PCN-20190527 TE0713-01-* to TE0713-02-* Hardware Revision Change

Company	Trenz Electronic GmbH
PCN Number	PCN-20190527
Title	TE0713-01-* to TE0713-02-* Hardware Revision Change
Subject	Hardware Revision Change
Issue Date	2019-05-27

#6 Full update LIB

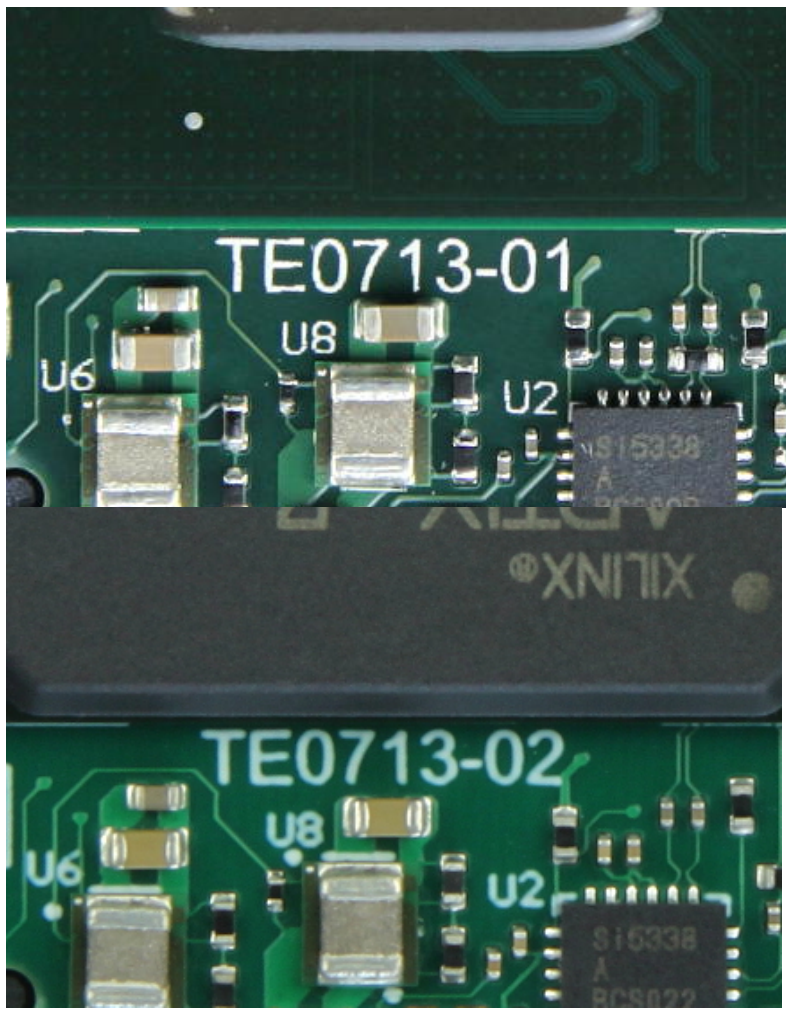
Type: PCB Change

Reason: Improve manufacturing yield
